8XC51SL

SPECIFICATION UPDATE

Release Date: July 1996

Order Number: 272877-001

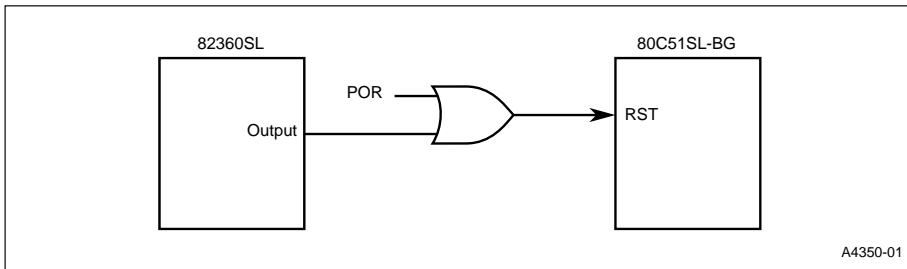
IMPLICATION : During any of the 8XC51SL-BG resets listed, a floating node within the 8XC51SL-BG may cause internal clock signals to be killed thus not allowing a valid reset.

WORKAROUND: Workaround #1 (external logic: 3 gates). This is Intel's recommended workaround.

Drive the 8XC51SL-BG CSL, RDL, and WRL pins low during RST to guarantee a valid RST reset (typically used for power-on reset [POR]). Driving these 8XC51SL-BG pins low during reset drives the floating node to a proper state which allows reset to occur. During the time CSL, RDL, and WRL are driven low, LED0, LED2, and PCOB0-7 will be driven low from the 8XC51SL-BG.

Driving CSL, RDL, and WRL low during RST ensures that a valid RST reset (POR) occurs. It is possible for the problem node to float during non-RST resets after it has been initially set during a RST reset with the workaround in place. If this occurs the system user will have to issue one or more additional resets if the first non-RST reset fails. However, bench test experimentation has shown no reset failures after a valid PD. was applied to RST with the workaround in place. The tests were conducted at room, hot, and cold temperatures for over 8 hours with several million software resets issued. Your system should be verified to confirm that no quality issue exists on the non-RST resets after implementing this workaround. The following figure shows a typical implementation of this work around.

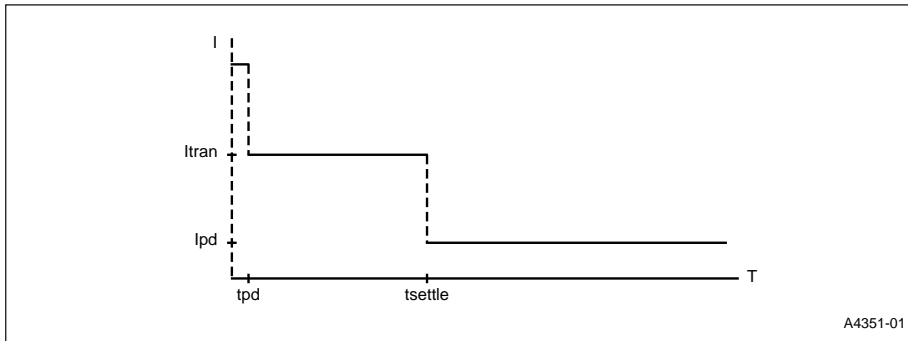
Workaround #2 (System BIOS modification, blue-wire, plus potential OR-gate). This is an alternative workaround.

Drive the 8XC51SL-BG RST input with a presently unused 82360SL output (blue-wire). If a valid 8XC51SL-BG reset is not detected (POST code error), the 82360SL will issue another reset to RST. Each system should be tested to ensure that having the 8XC51SL-BG powered before properly being reset does not cause any system problems. It may be beneficial to OR the present POR reset (if applicable) with the 82360SL system BIOS controlled reset signal to minimize this occurrence.

As with workaround #1, this workaround only directly addresses the RST reset and Intel recommends that each system model be tested to ensure that no quality issue exists with the additional reset sources.

The following figure shows a typical implementation of this workaround.
